Appendix F

Comment and Response

South Dakota PrairieWinds DEIS Comment and Response Tracking Table

Comment Reference Document 1
Attachment 3

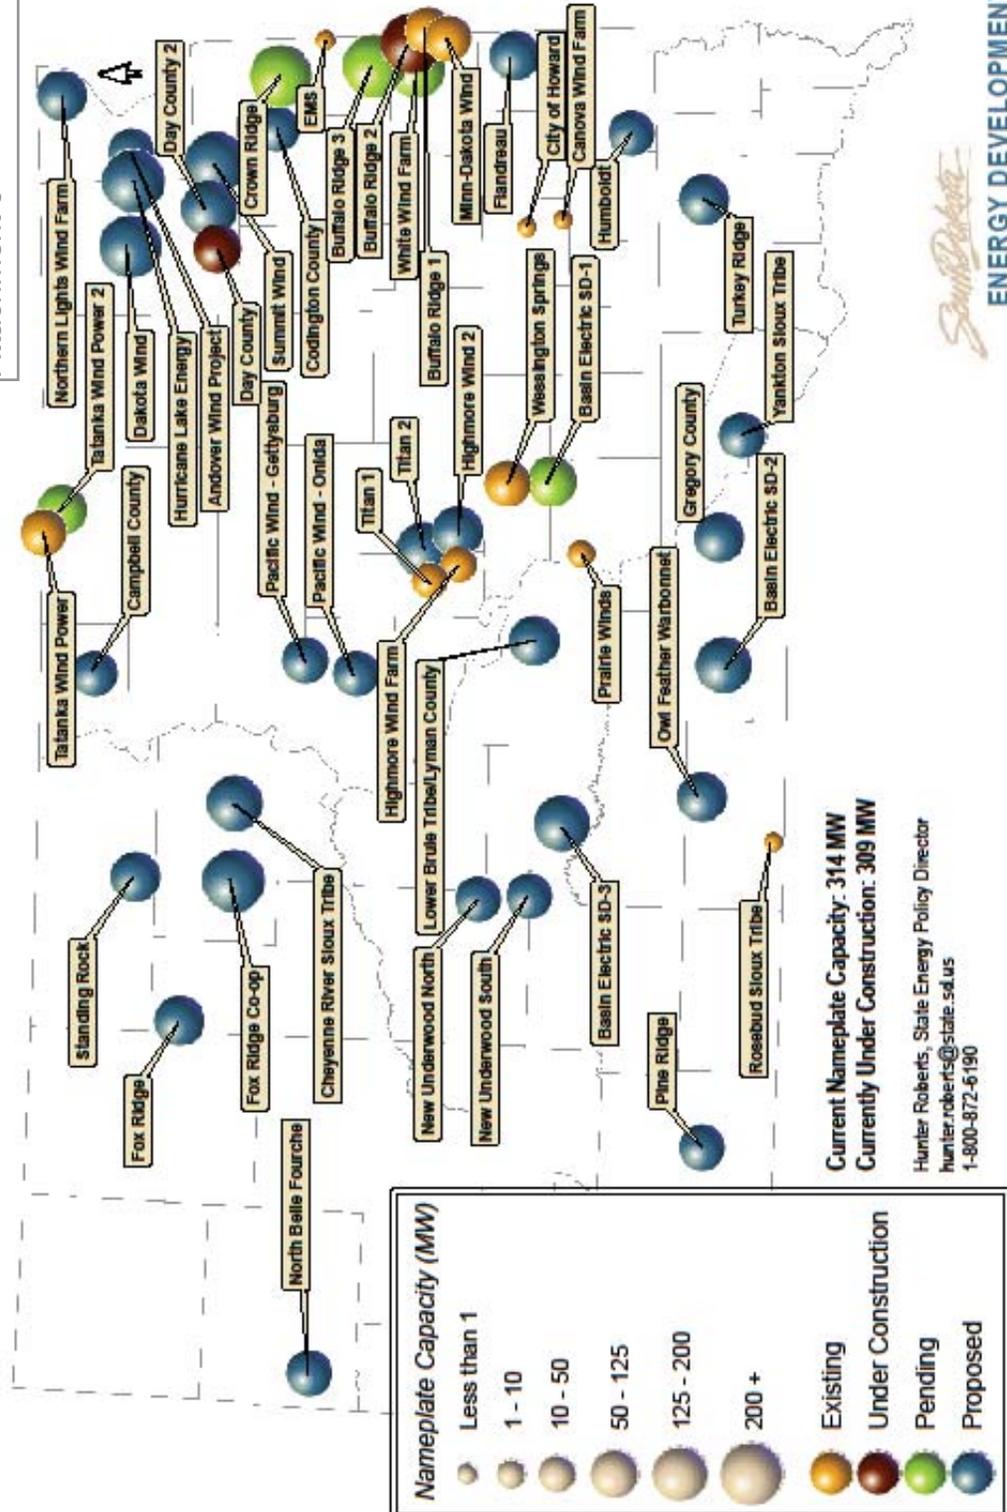
Comment Number	Commenter	Comment Category	Location of response in FEIS/or Treatment
1.48	USFWS	Cumulative impacts and the Map from the South Dakota Office of Economic Development with proposed projects [Attachment 3]	Noted. The process for determining which "past and present actions" and "reasonably foreseeable activities" were included in the cumulative impacts analysis as described in Section 5.3. Several new projects were added to this analysis and the cumulative impacts in FEIS Section 5.4.2 have been reevaluated, including those to migratory birds. Those "proposed" projects that were deemed "reasonably certain to occur" were included in the analysis. We have also updated Table 5.1 and added Figure 5.2 to include the proposed projects that are being carried forward in the analysis.

1.48 → Chapter 5, Cumulative Impacts. Information from the South Dakota Office of Economic Development pertaining to existing and proposed windfarm generation, is provided in Figure 2 (attached). This information implies cumulative impacts, in particular for migratory birds populations, at a magnitude much larger than the information discussed in the DEIS. (See our General Comments, herein, on this topic.)

Comment Number	Commenter	Comment Category	Location of response in FEIS/or Treatment
1, Attachment 2	USFWS	Central Flyway Whooping Crane Migration Corridor (Figure)	Incorporated into FEIS, see Figure 3.4-5.
1, Attachment 3	USFWS	South Dakota Wind Energy Development (Figure)	Evaluated for inclusion in cumulative impacts, see FEIS Section 5.3.
Federal
